**In The Drawings**

**REMARKS**

FIG. 4A

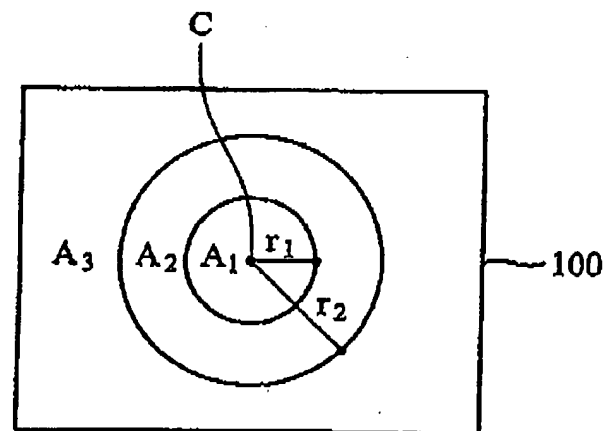
The attached sheet of drawings includes changes to Figs. 4A and 4B. In this sheet, Fig. 4A replaces original Fig.4, and new Fig. 4B is added.

Fig. 4B is a new drawing for illustrating "the size of the microlenses disposed in the center region is reduced by 5-50 % compared with the size of the microlenses disposed in the edge region" as recited in amended claim 5.

The Examiner is thanked for the thorough examination of the present application. The Office Action, however, tentatively rejected all claims 1-27. Applicant has relabeled FIG. 4 as FIG. 4A, and has added new FIG. 4B, to more clearly illustrate a novel and non-obvious feature of original claim 5. Support for this limitation can be found on page 8 lines 2-17 of the specification and in Fig. 4. Therefore no new matter has been added to the application by the addition of this drawing sheet.
